Errata Sheet

Product Family: Terminator I/O **Date:** December 2018
Manual Number T1K-DEVNETS-M
Revision and Date 1st Edition; November 2001

Changes to Chapter 2. Installing the T1K-DEVNETS Base Controller

Page 2-9. Configuring the Controller; Status Indicators

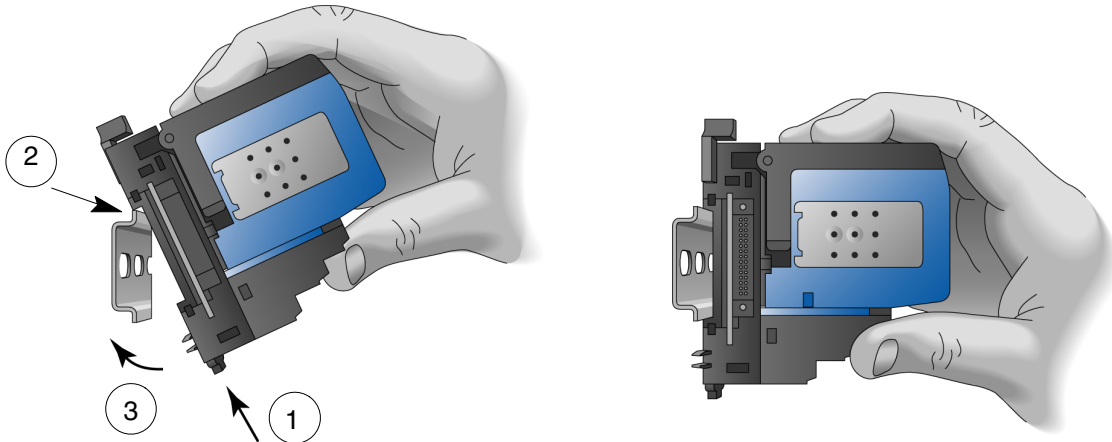
Replace the top portion of the table [MS (Module Status) Indicator] with the table below.

Two new rows were added for Flashing Green and Flashing Red.

No changes were made to the lower portion of the table [NS (Network Status) Indicator].

MS (Module Status) Indicator	
Indication	Status
OFF	No power to Controller. Check wiring.
ON (Green)	Power applied to Controller, no fault
ON (Red)	Critical Controller Fault
Flashing Green	In Firmware Update Mode
Flashing Red	I/O system error Missing module error New module present error I/O diagnostic error
